Towards a semi-asynchronous method for hydrological modelling in climate change studies

RC2 (https://doi.org/10.5194/egusphere-2025-4450-RC2)

Figure 1. Performance comparison between the conventional method calibrated using RMSE and KGE for the Matane catchment during the reference period (1981–2010). The figure shows the percentage bias between observed and simulated streamflows obtained using meteorological observations.

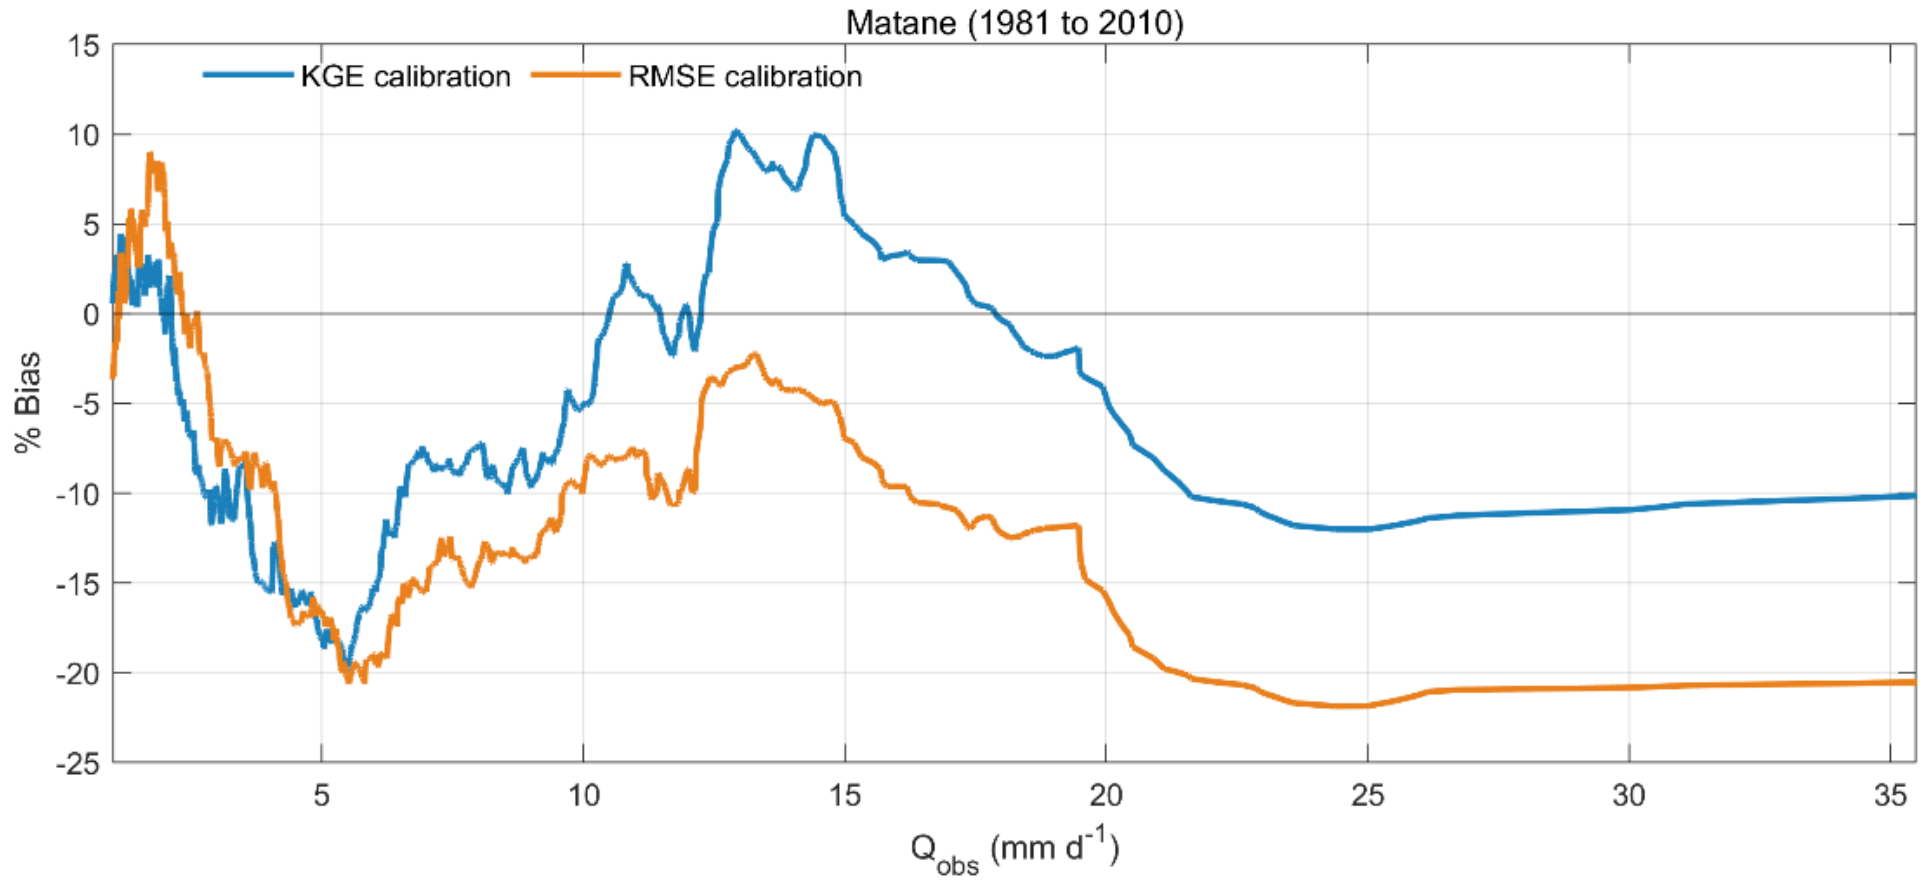
8. Lines 378 – 399: Figure 4 shows that the conventional method tends to underperform in reproducing extreme events, mainly high flows. This may relate to the objective function that is selected: KGE for the conventional method, but RMSE for the asynchronous methods. Peak flows dominate the RMSE objective function, while the KGE focuses more on mean flows. It is suggested to check model performance when a model is calibrated using the conventional method but with a similar objective function (RMSE or NSE).

This answer is similar to a previous answer to RC1. To address this point, we recalibrated the conventional method for the Matane catchment using RMSE, in addition to the original calibration based on KGE. This additional analysis was performed to provide a more consistent basis for comparison with the fully asynchronous and semi-asynchronous methods, which both rely on RMSE-based objective functions.

The results obtained for the reference period show that calibrating the conventional method with RMSE does not improve its ability to reproduce high flows compared with the original KGE-based calibration. In fact, the RMSE-based calibration performs slightly worse in this regard. As expected, each calibration performs better according to its own objective function, with the KGE-based calibration yielding a higher KGE and the RMSE-based calibration yielding a lower RMSE. However, both approaches produce very similar hydrographs and overall model behaviour.

These results suggest that, although the choice of objective function introduces some degree of uncertainty, it does not substantially alter the overall performance of the conventional method or the main conclusions of the study. In particular, the lower performance of the conventional method in reproducing extreme flood events cannot be attributed solely to the use of KGE instead of RMSE.

To document this analysis, we added two figures in the response file showing the comparison between the conventional method calibrated with RMSE and KGE for the Matane catchment during the reference period.

To address this point, we will add the following sentence to Section 4.2 and will add the two figures to the Appendix G:

"In addition, the choice of objective function used during calibration of the conventional method represents another source of uncertainty. Nevertheless, sensitivity tests conducted on the Matane catchment showed that using RMSE instead of KGE for the conventional method leads to very similar results, indicating that this choice does not significantly influence the conclusions of the study (Appendix G)."
